HISTORIC PRESERVATION ADVISORY BOARD MEETING
CITY HALL, 385 SOUTH GOLIAD, ROCKWALL, TEXAS
JANUARY 18, 2024 IN THE CITY COUNCIL CHAMBERS AT 6:00 PM

Hold a public hearing to discuss and consider a request by Chris Beardon of MSMC Group for the approval of a Certificate of Appropriateness (COA) for the purpose of remodeling an existing non-residential building that is designated as a Non-Contributing Property being a 0.66-acre tract of land identified as Lots 1 & 2, Block A, Thomas & Smith Addition, City of Rockwall, Rockwall County, Texas, zoned Downtown (DT) District, situated within the Old Town Rockwall (OTR) Historic District, addressed as 308 N. Fannin Street, and take any action necessary.

HISTORIC PRESERVATION ADVISORY BOARD CASE MEMO

TO: Historic Preservation Advisory Board
DATE: January 18, 2024
APPLICANT: Chris Beardon; *MSMC Group*
CASE NUMBER: H2024-001; *Certificate of Appropriateness (COA) for 308 N. Fannin Street*

EXTERIOR ELEVATIONS

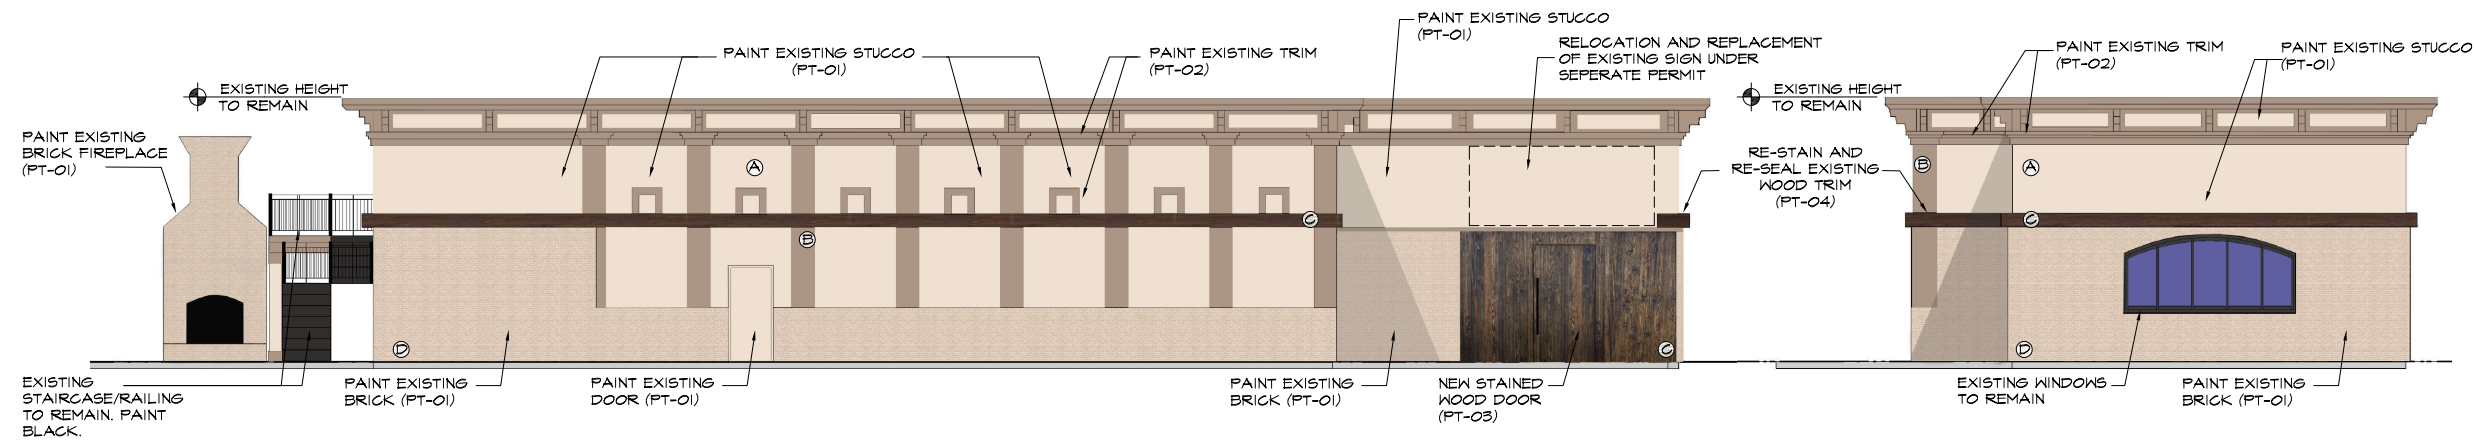
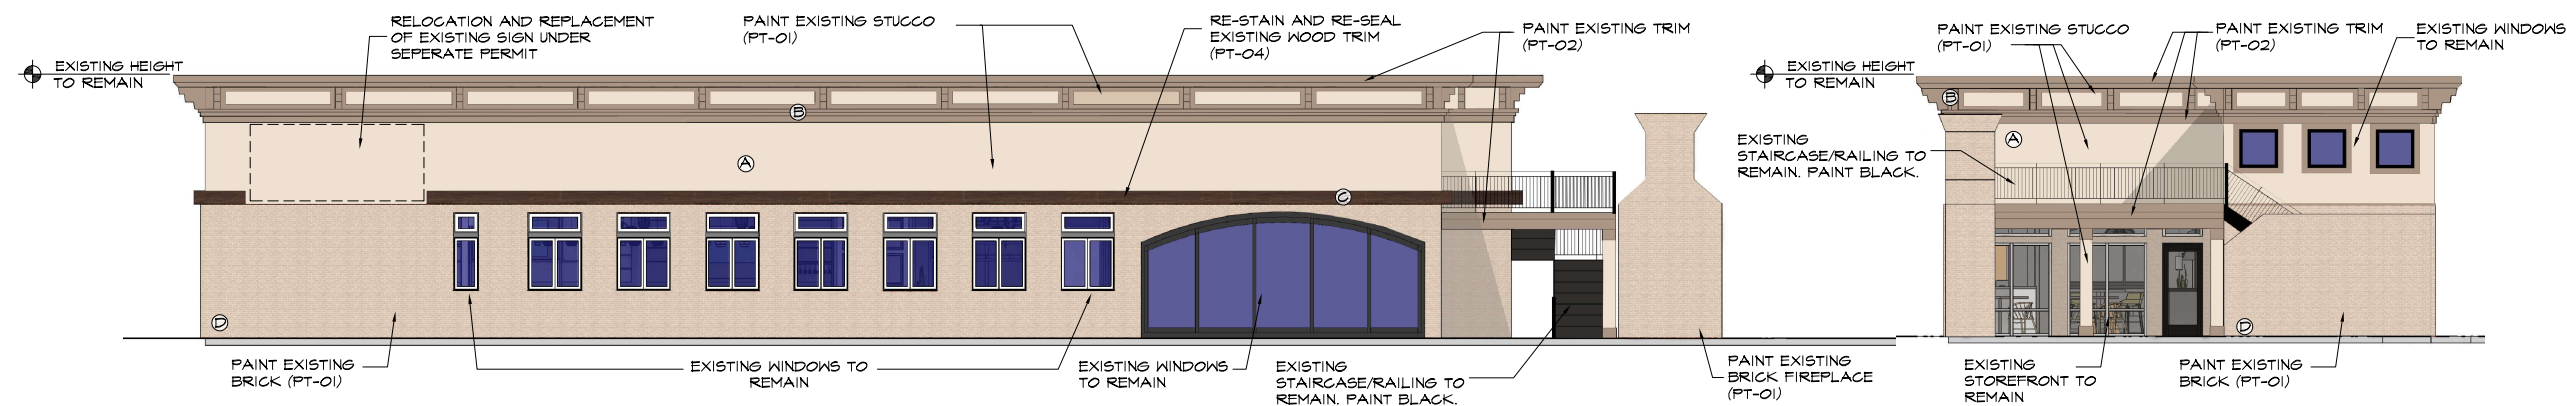
On December 29, 2023 the applicant submit an application requesting approval of a Certificate of Appropriateness (COA) to allow the remodel of an existing non-residential building on the subject property. Based on the building elevations provided by the applicant they are proposing to [1] replace the existing entryway glass and door, and [2] paint the exterior of the building, including the brick. Staff should note that the applicant had already replaced the entryway glass and door prior to submitting or receiving a Certificate of Appropriateness (COA).

(a) *Building Facades and Materials*. According to Section 07(C), of Appendix D, *Historic Preservation Guidelines*, of the Unified Development Code (UDC), "(i)n cases where the original exterior facade materials are unavailable, complementary exterior materials may be used." This section continues by listing how different architectural elements may be changed as long as they are in the style and period of the building. In this case, the existing building is considered *Non-Contributing* within the Old Town Rockwall (OTR) Historic District and was constructed in 2006. Given this, when reviewing the replacement of the entryway glass and door, the HPAB should consider whether this scope of work will have a negative impact on any of the adjacent properties, rather than the historical integrity of the subject property

(b) *Paint and Color*. According to Section 07(M), of Appendix D, *Historic Preservations Guidelines*, of the Unified Development Code (UDC) "(b)rick, stone or other naturally or historically unpainted materials should not be painted unless the material has been painted before." In this case, the existing stucco and wood accents have been previously painted; however, the brick has never been painted. With this being said, the structure is not historically significant and the painting of the brick would not change this; however, the HPAB has discretion over whether the brick shall be painted, and if painted, to determine if it would adversely affect the character of the site. In addition, the *Historic Preservation Guidelines* discourage "(f)lorescent and metallic colors."

If the Historic Preservation Advisory Board (HPAB) chooses to approve the request for a *Certificate of Appropriateness (COA)*, staff would propose the following conditions of approval:

(1) Any construction resulting from the approval of this request shall conform to the requirements set forth by the Unified Development Code (UDC), the International Building Code (IBC), the Rockwall Municipal Code of Ordinances, city adopted
